PERMIT

SEWAGE DISPOSAL SYSTEM

A REPAIR

SUBDIVISION _____ ROAD 14809 Burntwoods Road LOT 2947

INDICATE NORTH - NAME ADJOINING ROADWAY AS BASE LINE
 Burntwoods Road

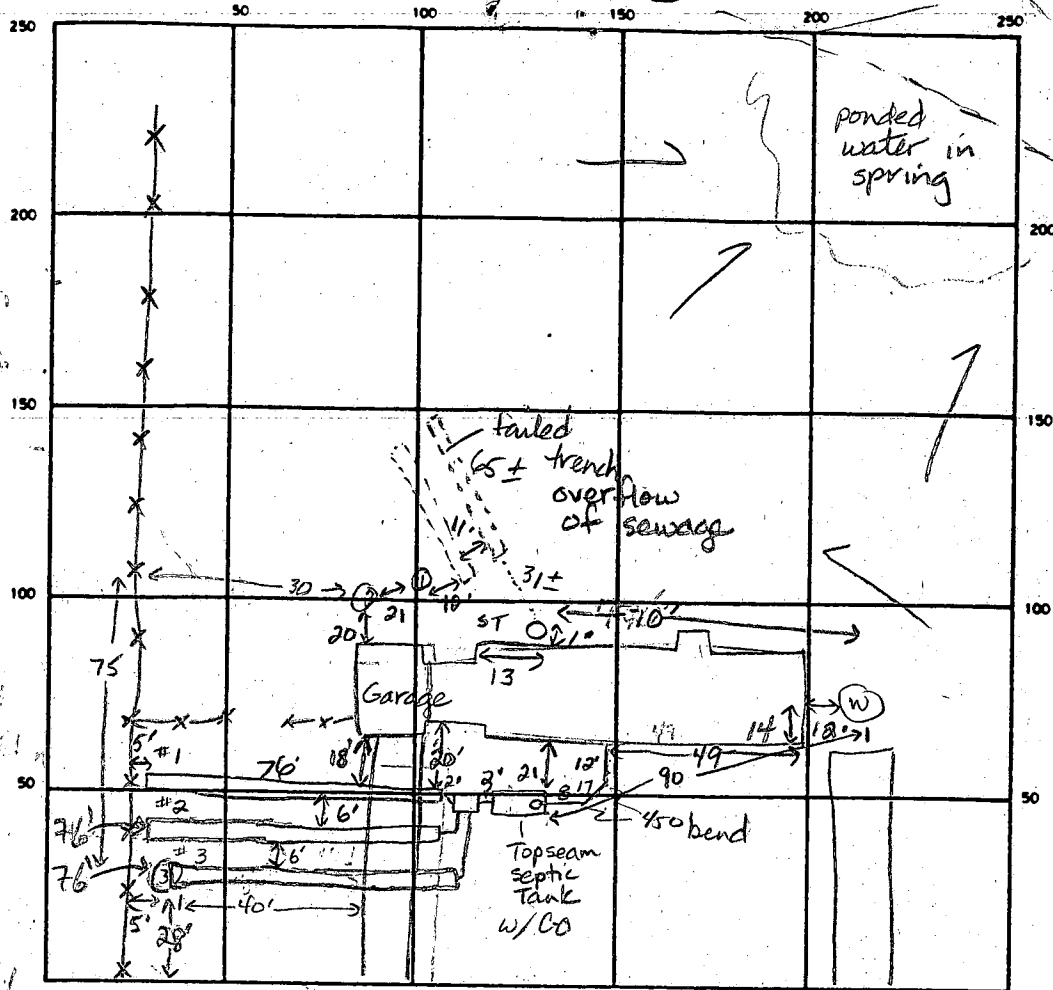
REMARKS 11-29-89 s. tank at house well-plugged full. Recommend moving tank 10 ft away from house in front yard. JEN 1-23-90 OK to continue with trenches. Keep minimum of 20 ft between breezeway and house. JEN 1-24-90 OK to cover trench #1 and stone #2. JEN 1/24/90 OK TO STONE AND COVER ALL MR

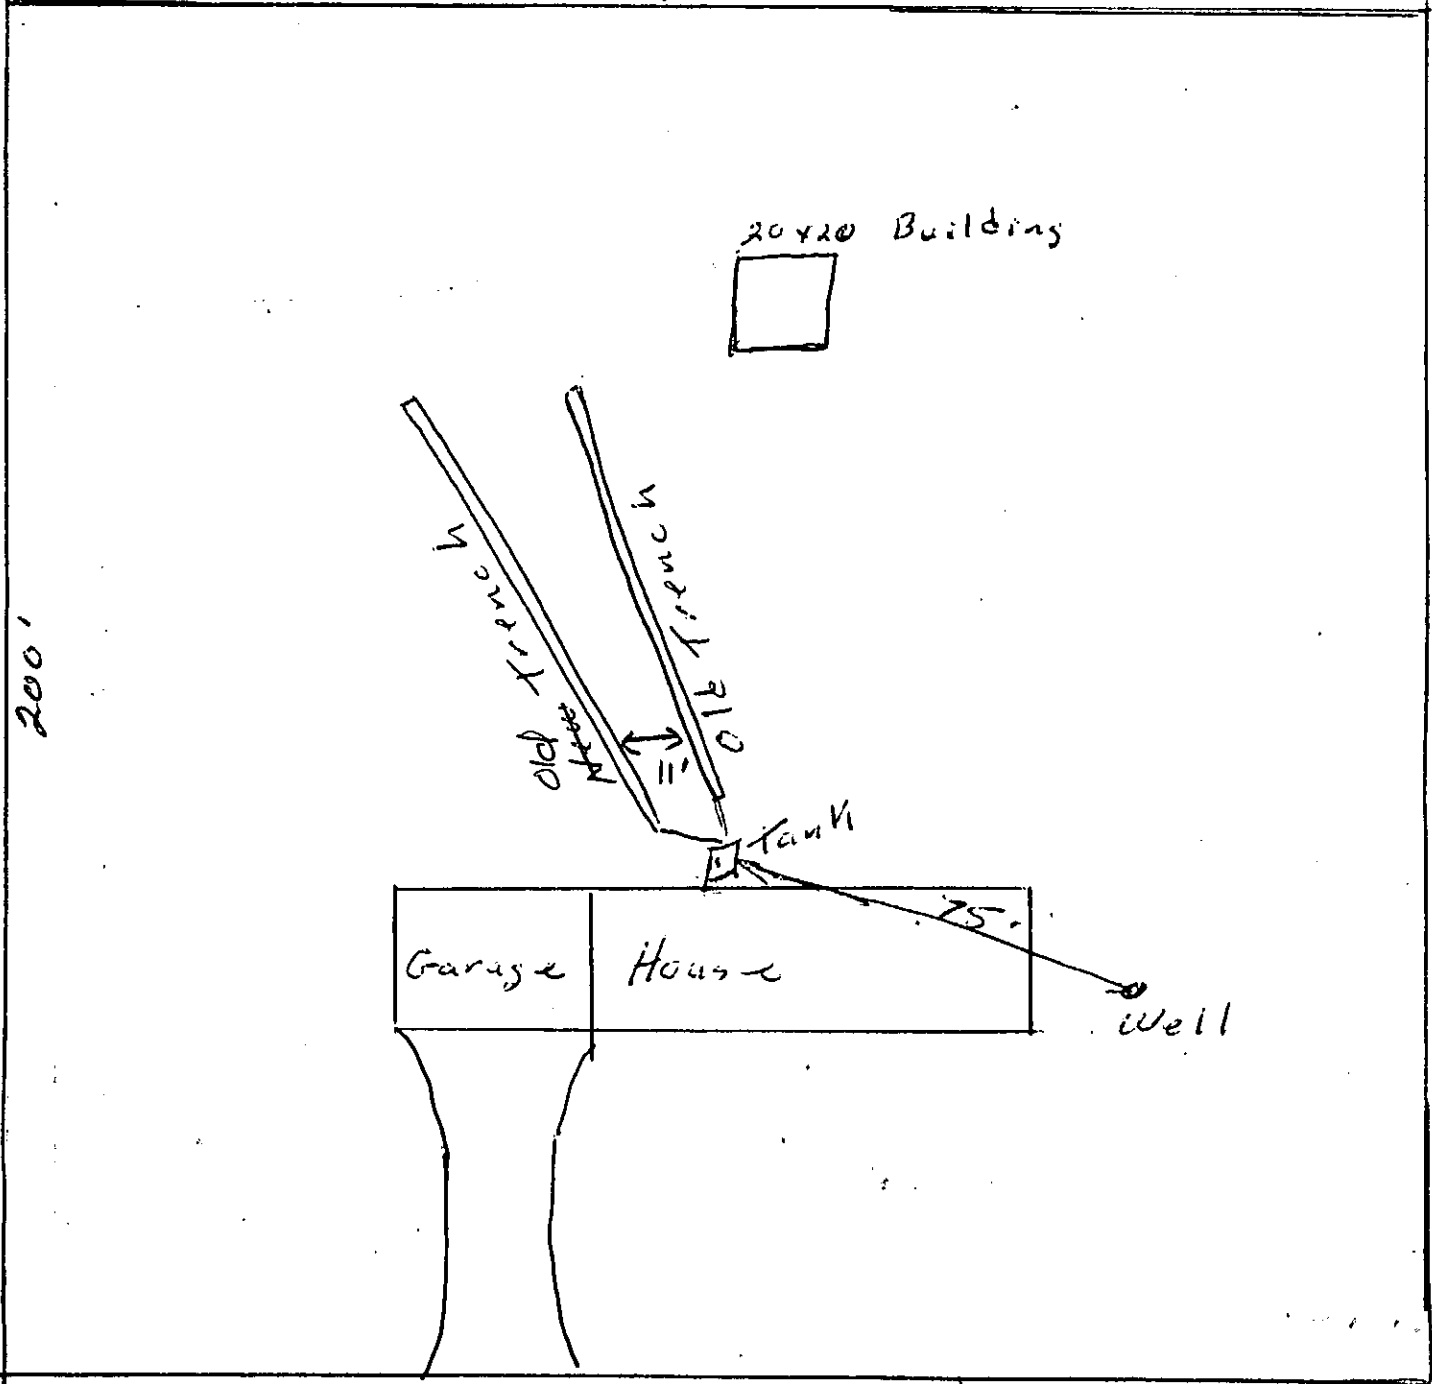
REASONS FOR REJECTION OR HOLDING 11-29-89 For repair to existing system.
New trenches necessary, JEN 12-1-89 Top seam septic tank
recommended with 4ft wide trenches. Maintain 100ft from
well. JEN
